**Drainage Memo
for
Lot 1, Seder Subdivision
(A Replat of Lot 7, Akers Acres Subdivision No. 1)
2725 Akers Drive
El Paso County, Colorado 80922**

Kiowa Project No. 24060
January 31, 2025

PCD File PPR255

V1_Drainage Letter.pdf Markup Summary

Figure 3

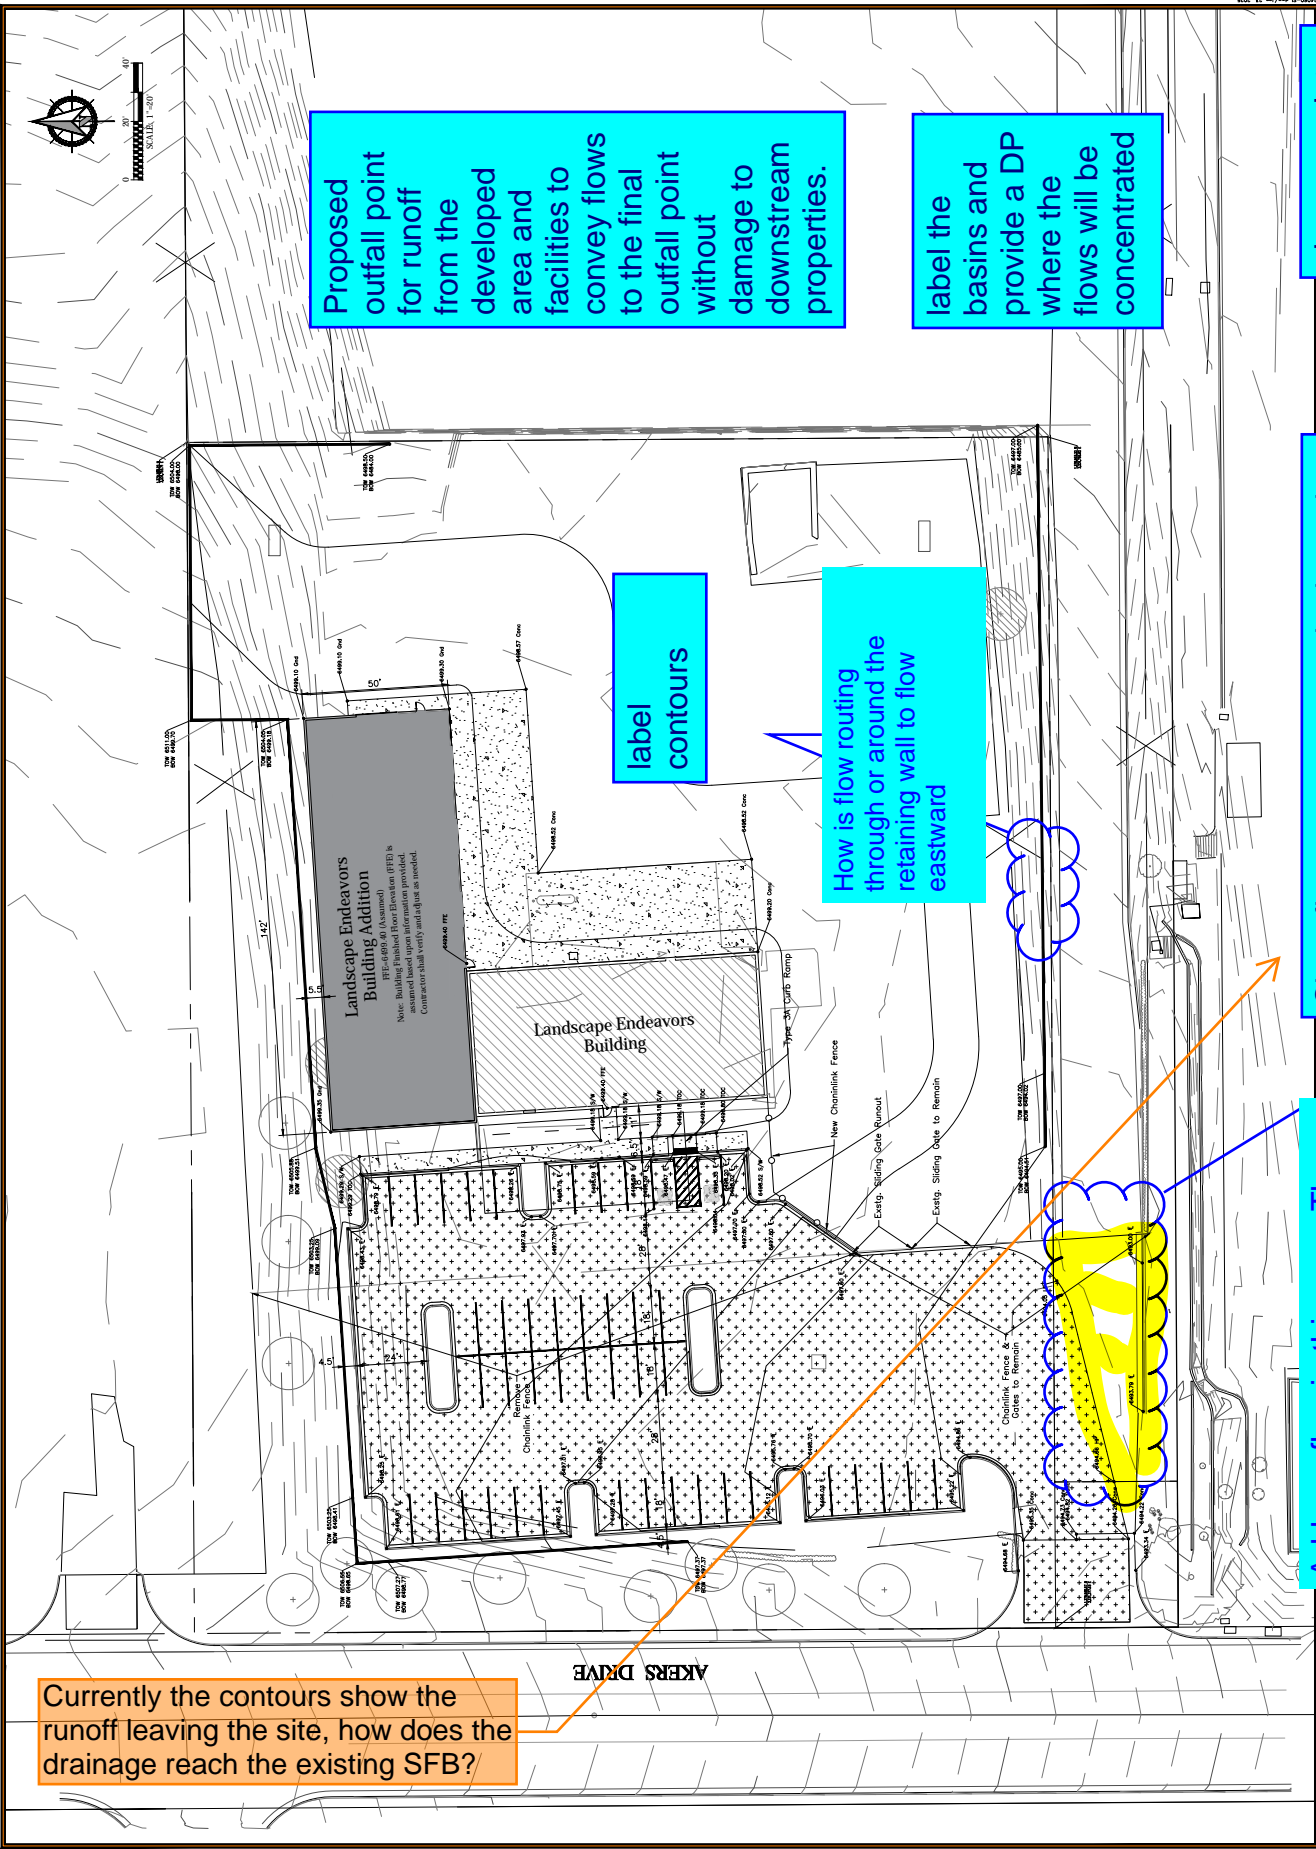
Provide existing condition drainage map Use excerpt from the original approved drainage report.

Proposed outfall point for runoff from the developed area and facilities to convey flows to the final outfall point without damage to downstream properties.

label the basins and provide a DP where the flows will be concentrated

show complete drainage map to the existing pond

label contours

How is flow routing through or around the retaining wall to flow eastward

Show flow arrows across the lot and to detention basin

Address flow in this area. The GEC plan shows this area not being paved or stabilized. Site flows cannot discharge to the ROW

Currently the contours show the runoff leaving the site, how does the drainage reach the existing SFB?
